ADDENDUM NUMBER: ONE (1)

DATE: May 2, 2024

PROJECT: ATHLETIC COMPLEX AT STOKES FIELD
COMMUNITY CENTER RENOVATION

DESIGNER: MONTGOMERY COUNTY ENGINEERING

MONTGOMERY COUNTY
TENNESSEE
ATHLETIC COMPLEX AT STOKES FIELD
BUILDING SECTIONS - BUILDING #1

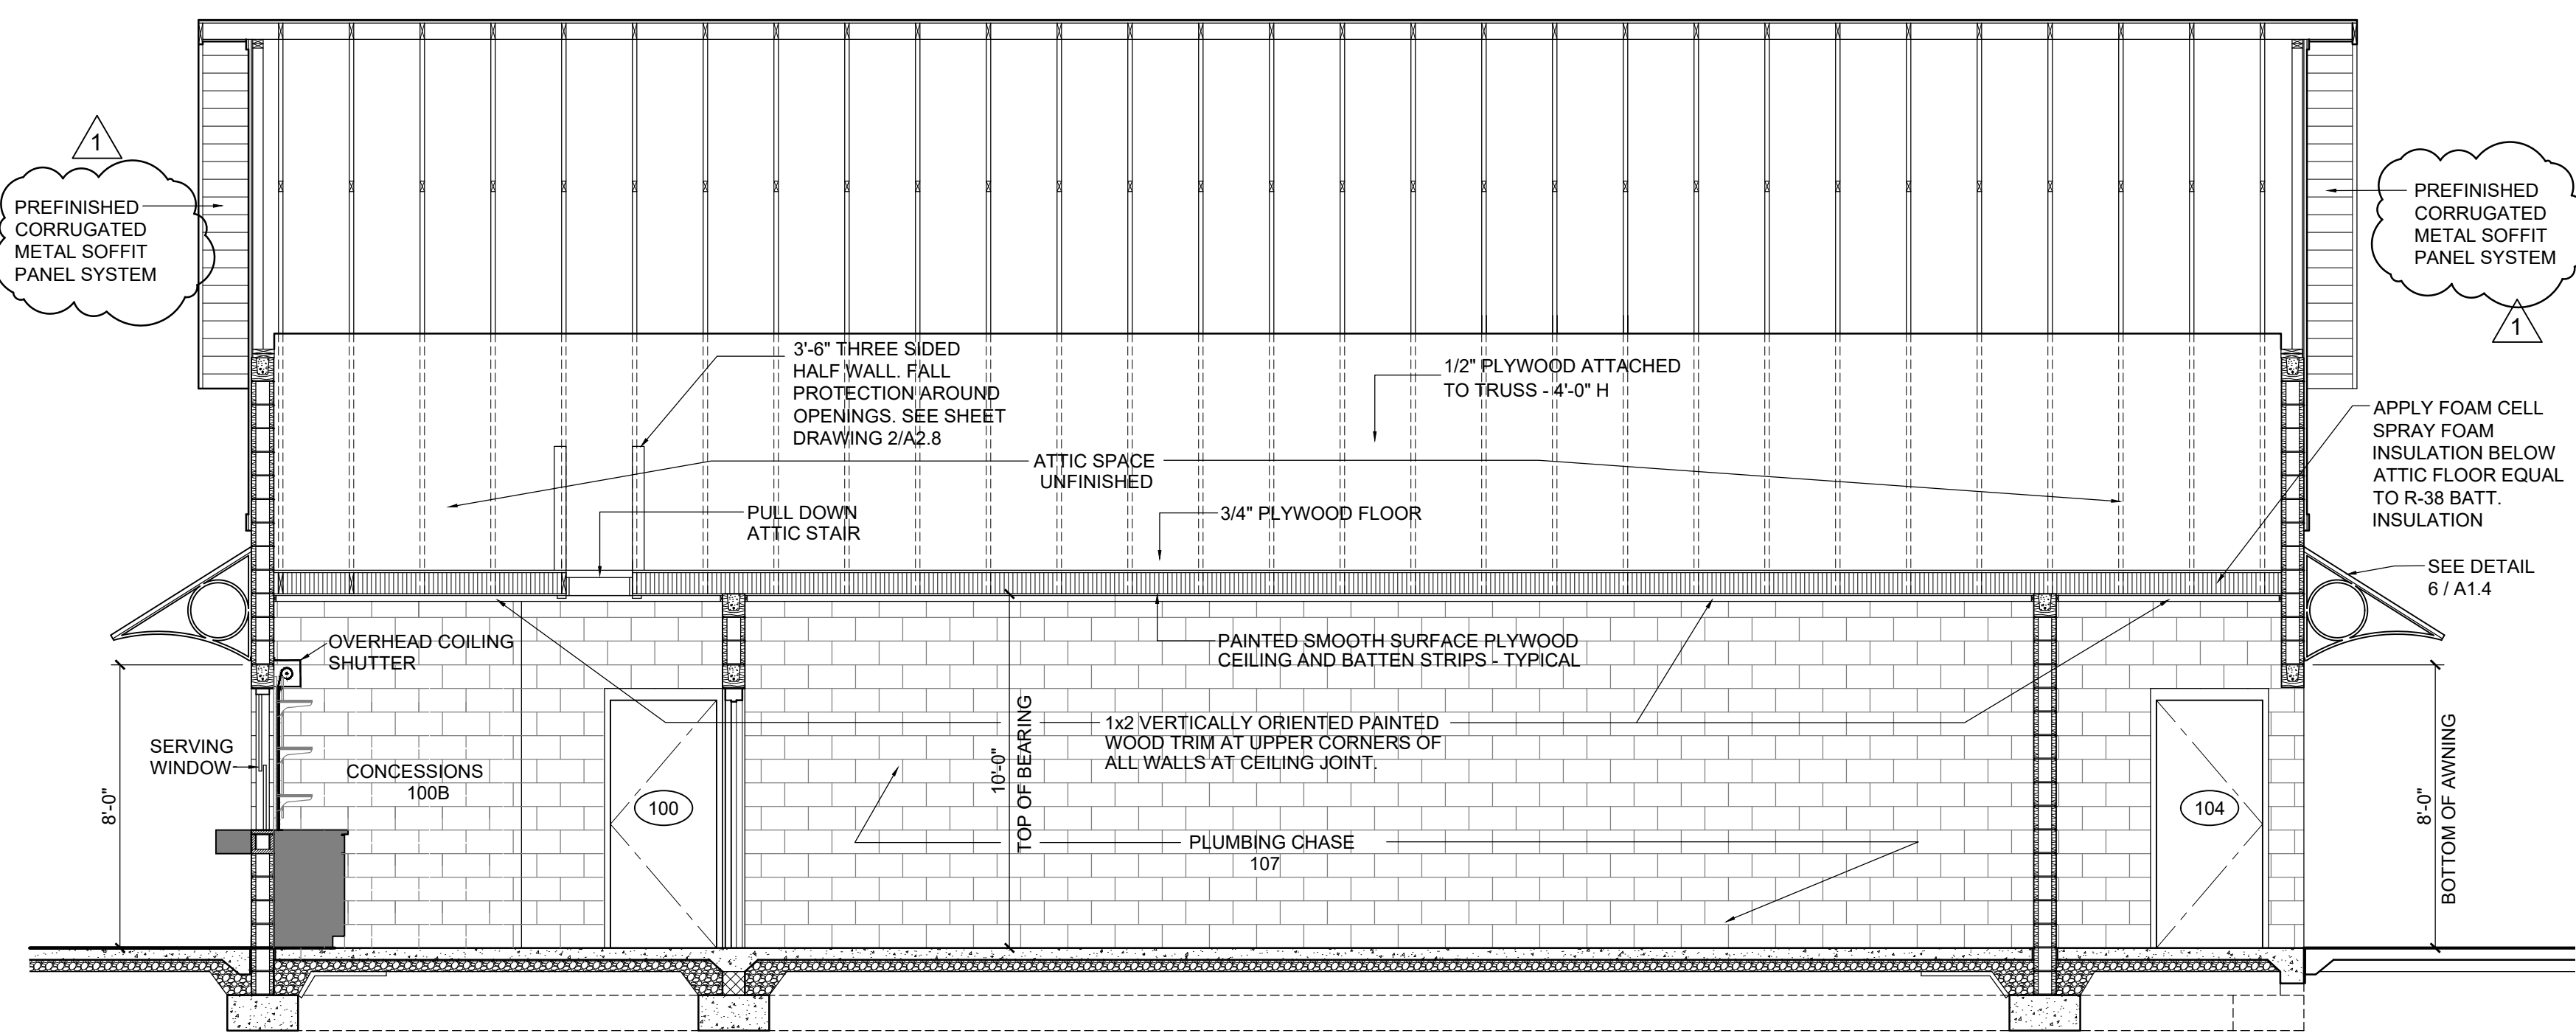
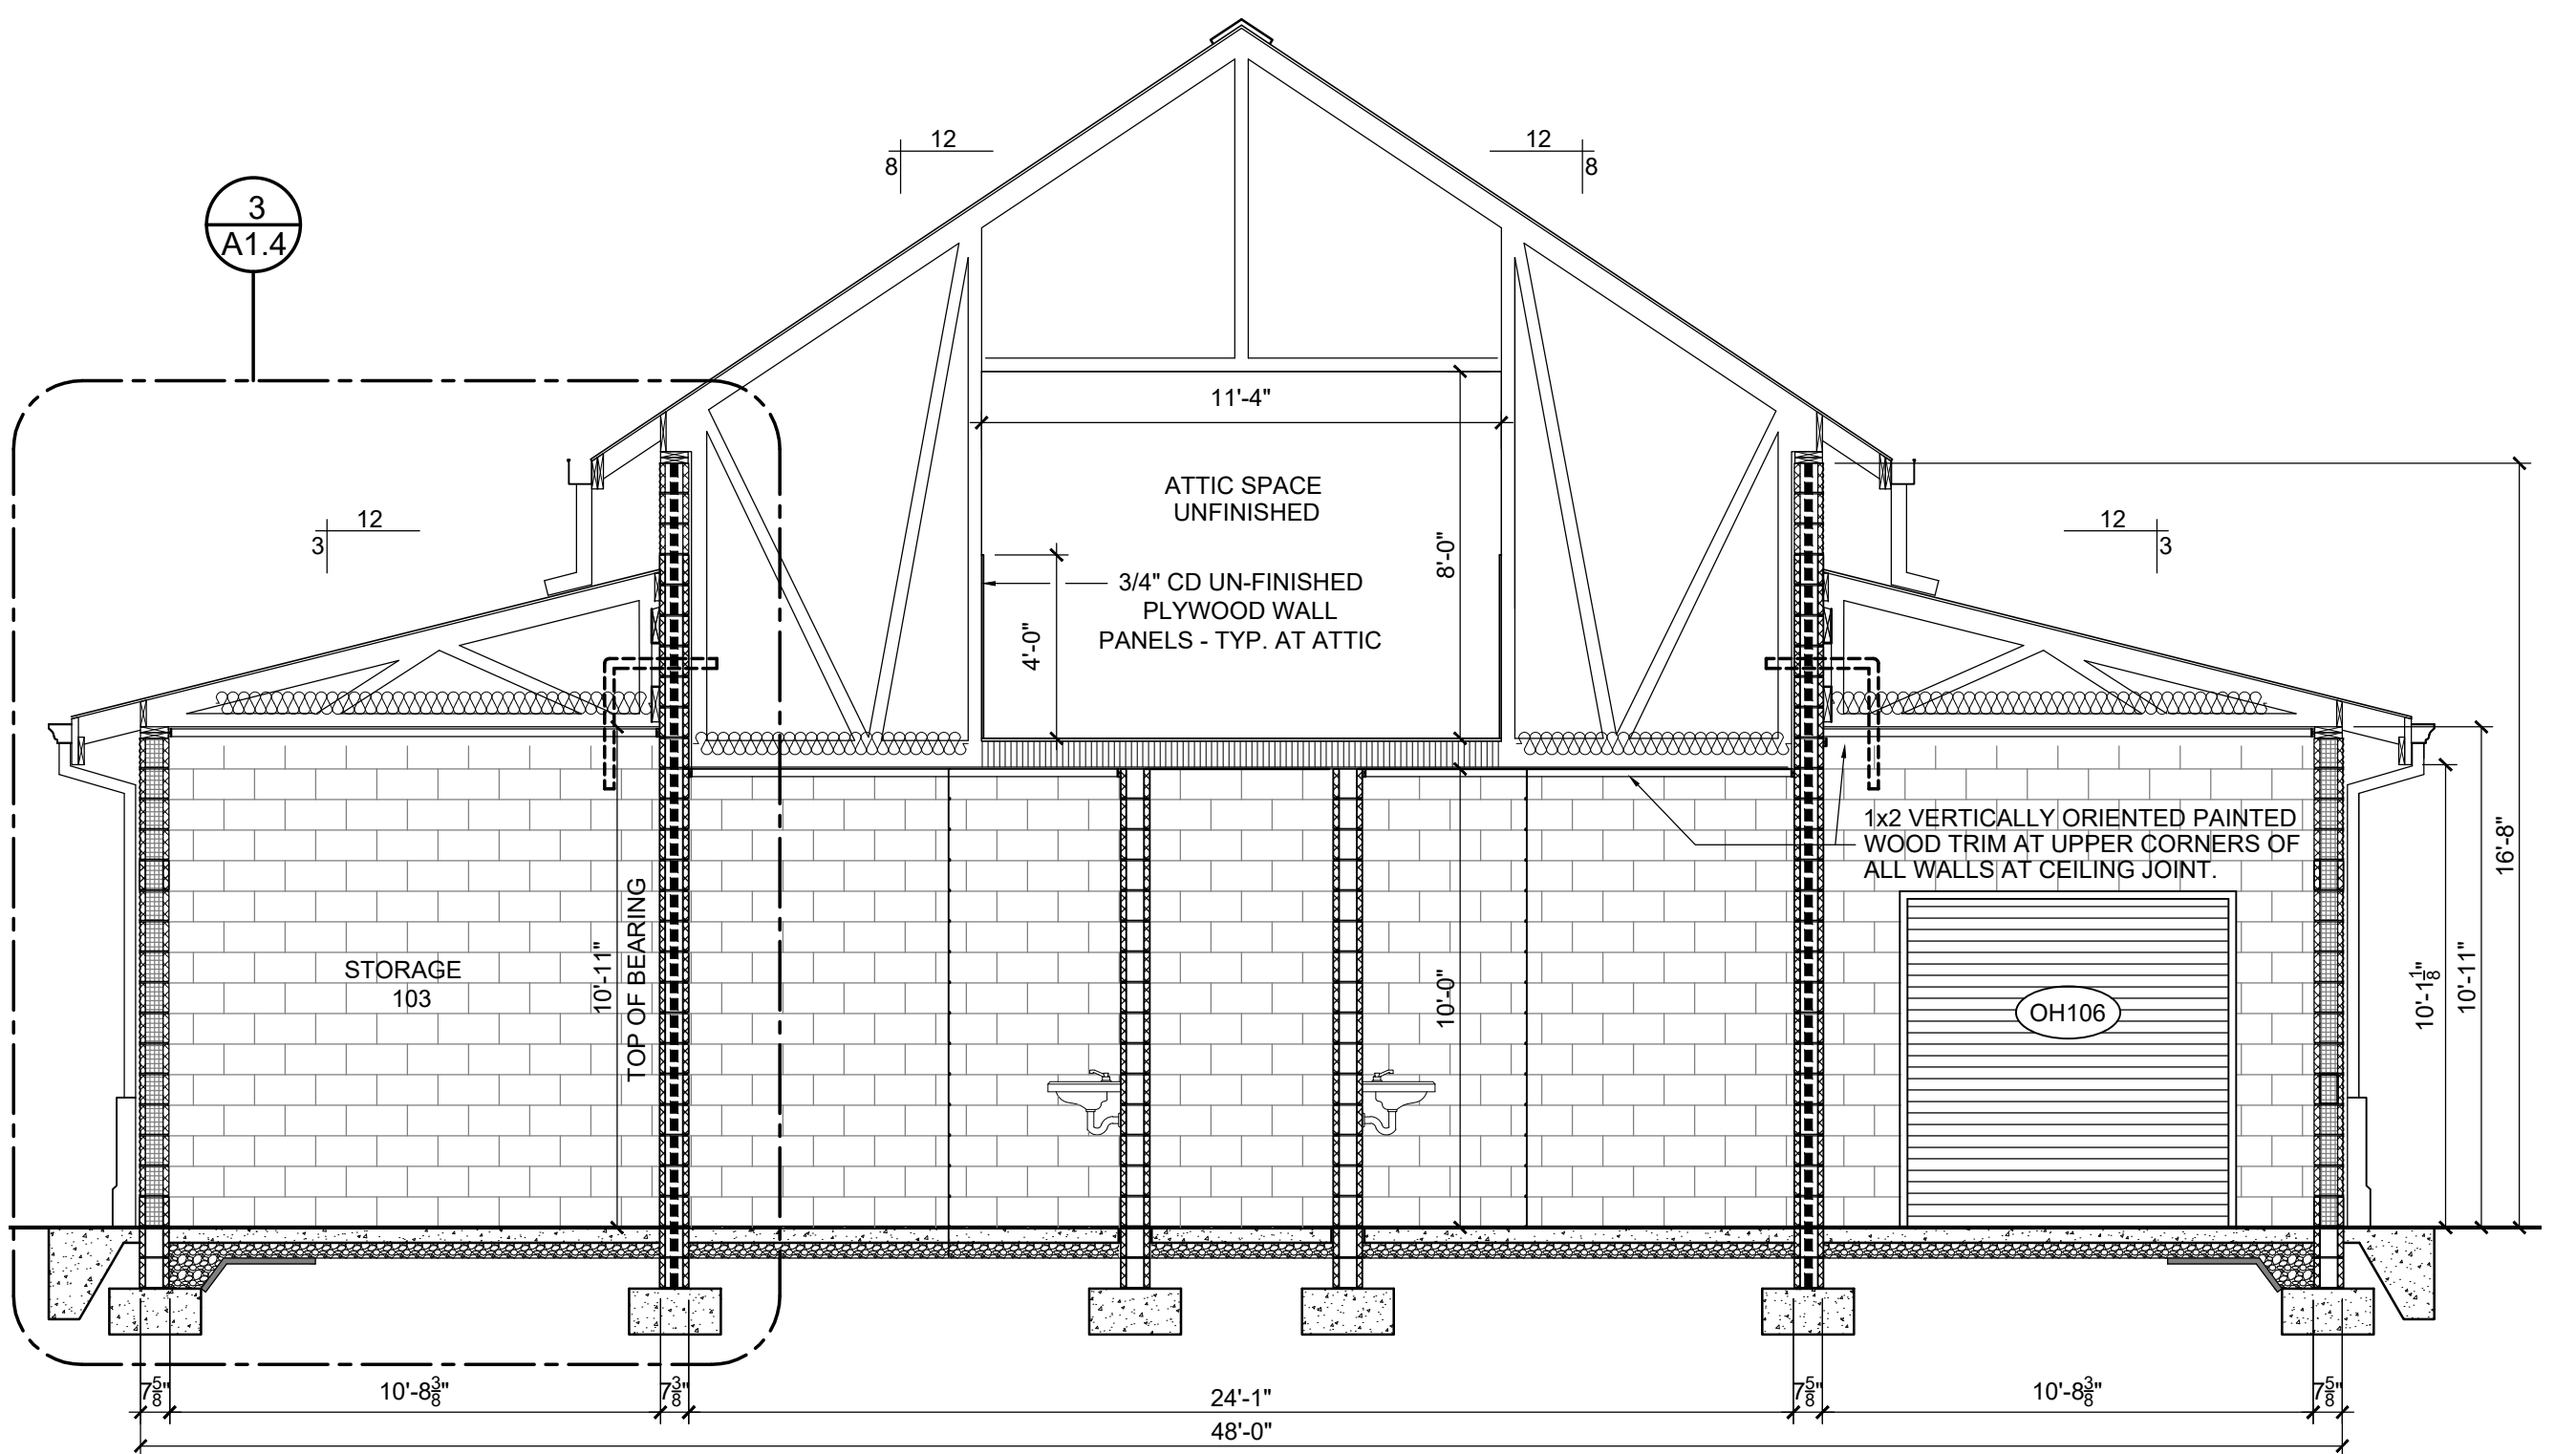
3. Drawing Sheet A1.4: Drawing A1.4 is revised and dated 4-30-2024 and replaces the original A1.4. Notes to a section detail calling out the soffit material has been revised to call out Pre-finished Corrugated Metal Soffit Material.

- Q.** Does metal ceiling of cooking pavilion attach to wood 2x10 purlins?
A. See revised sheet A1.4 and specification section 074110 for new details.
- Q.** Plan A3.0 Detail 1 shows spigot in Northeast corner of building, note says see plumbing drawing but there is no plumbing drawing for this building.?
